**SAN ANTONIO WATER SYSTEM
HIGHLAND ESTATES, UNIT 1 P.U.D. MONTANA PASS FLOATING GROUND
STORAGE TANK PROJECT**

**SAWS JOB NUMBER 15-1177
SOLICITATION NO. CO-00092**

**ADDENDUM NO. 5
October 13, 2016**

SHEET C4.0R

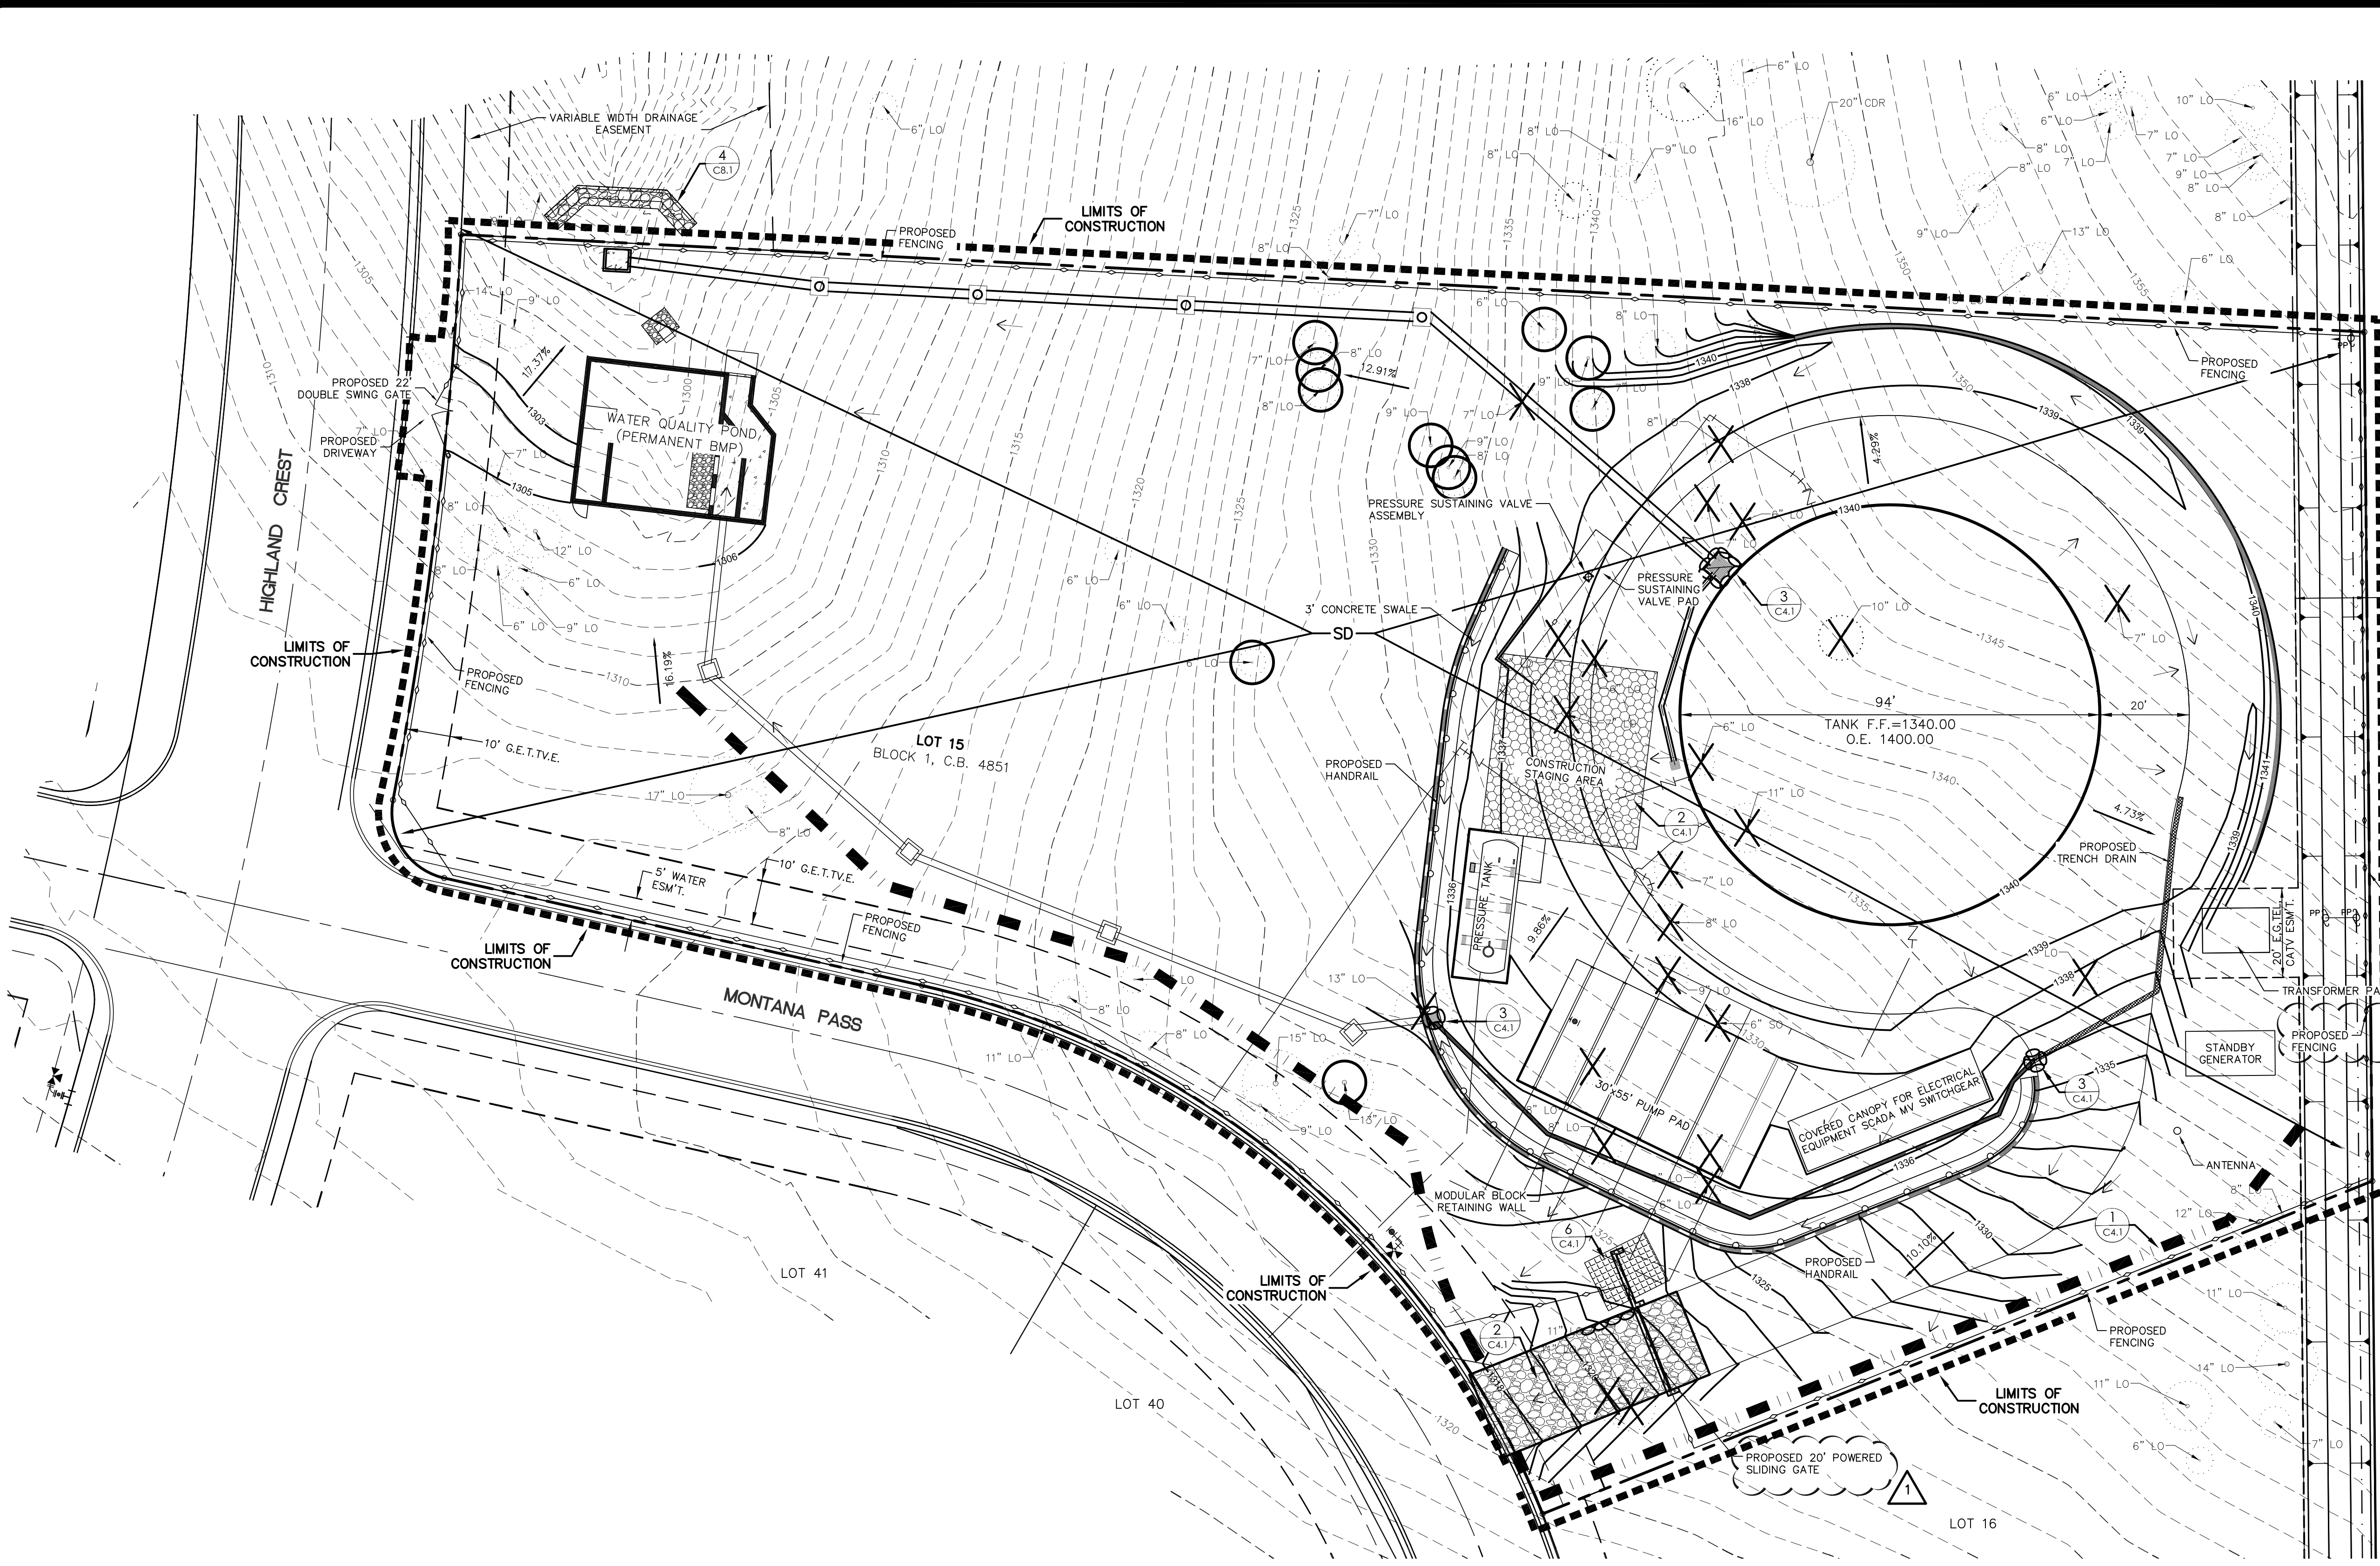
13. On sheet C-4.0 both site gates are shown to be 22' double swing gates, but on sheet C-5.1 the gate coming off of Montana Pass is shown to be a 20' powered sliding gate. Which gate is correct?
Gates shall be as shown on Sheet C5.1 with a double swing gate off Highland Crest and a 20' powered sliding gate off Montana Pass. Reference C4.0R1 and C5.1R1.

14. Is there fence required on the East side of the site running parallel to the existing fence? Sheet C-4.0 appears to show us tying into the existing fence running North and South, but sheet C-5.1 shows proposed fence running North and South alongside the existing fence.
Fence shall follow layout on sheet C5.1. Reference C4.0R1 and C5.1R1.

DEVELOPER: SAWS	
CONT.	BUDGET PROJ.
SUBMITTED _____	
APPROVED _____	
MAP No.	SHEET
SECT. No.	C-5R1
DR.	CK.
JOB No. 15-1177

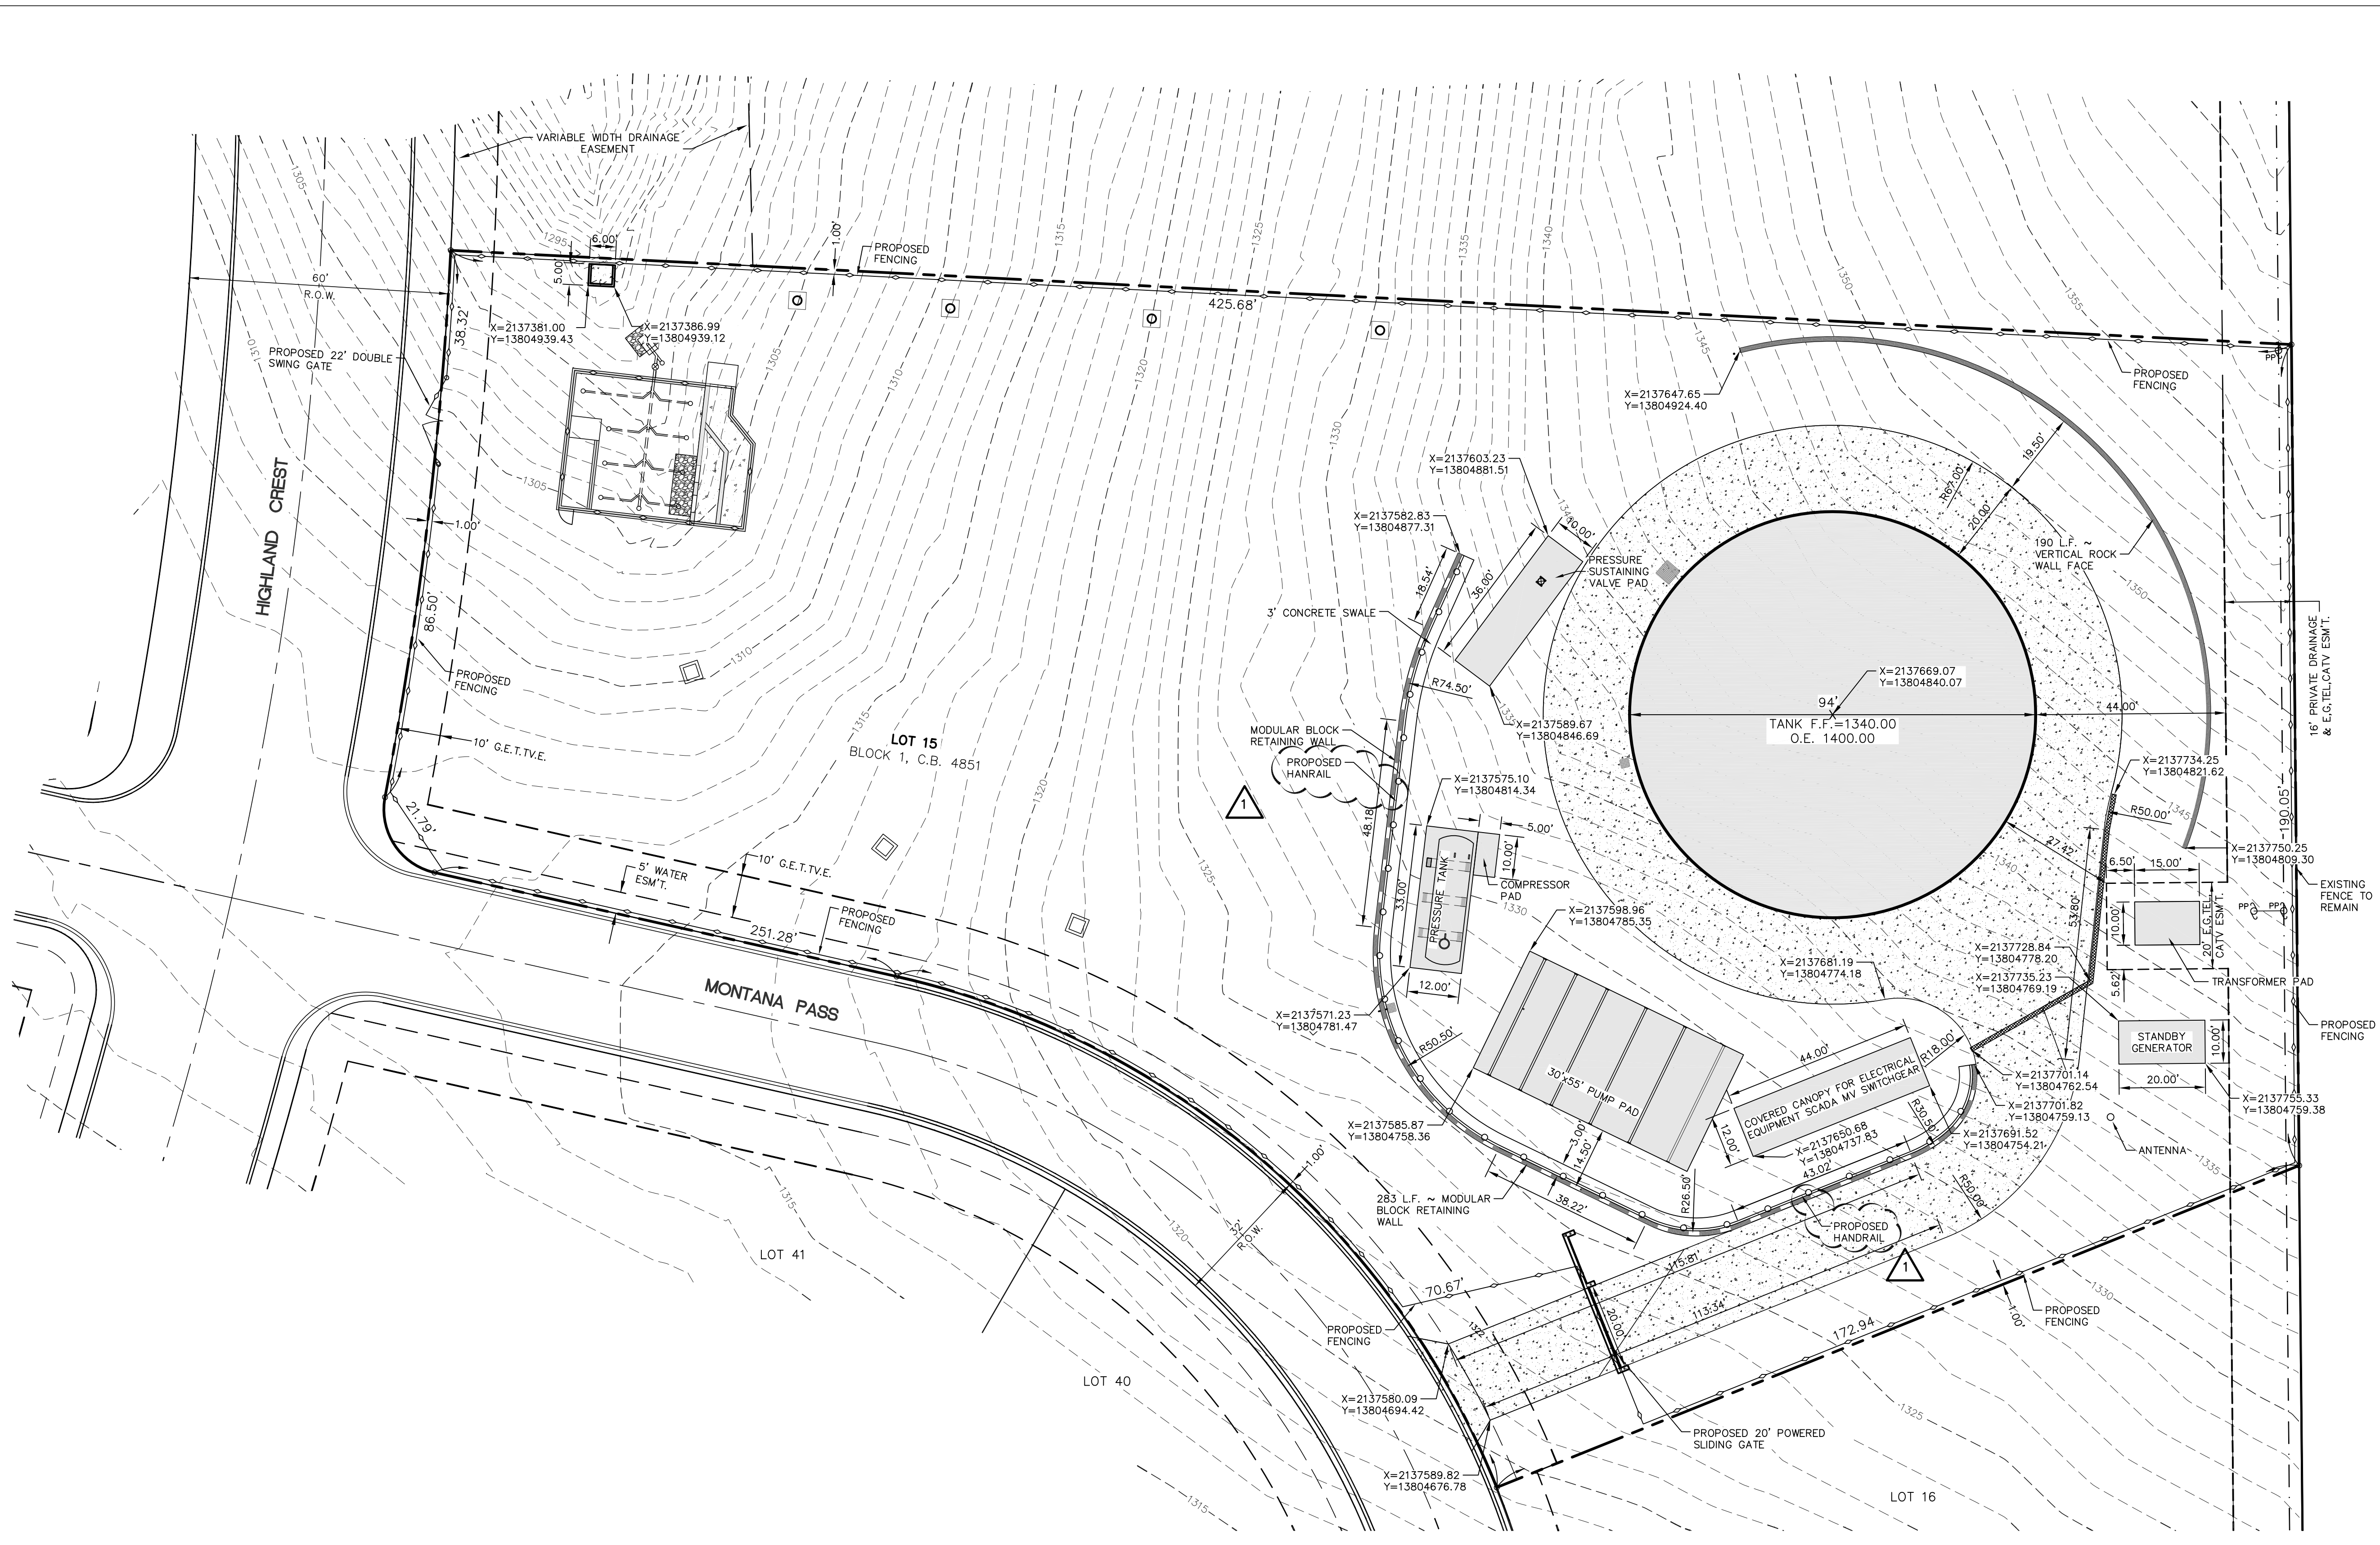
11. We do not have drawing C-4.8 for this project.
Sheet C4.8 is void; it has been removed as part of this Addendum.
12. Is there chain link fence or handrail required at the modular block retaining wall? There appears to be something indicated on the site plans, but nothing is called out anywhere or shown on the cut sections.
A handrail is required at the modular block retaining wall. Reference C5 R1 and C5.1 R1.

16. What is required at the 190' of vertical rock wall face shown on sheet C-5?
The intent is to leave the rock exposed in its natural state.
17. Is there a weir plate required at the flow splitter weir, or is this just a concrete weir wall?
Flow splitter is a concrete wall.
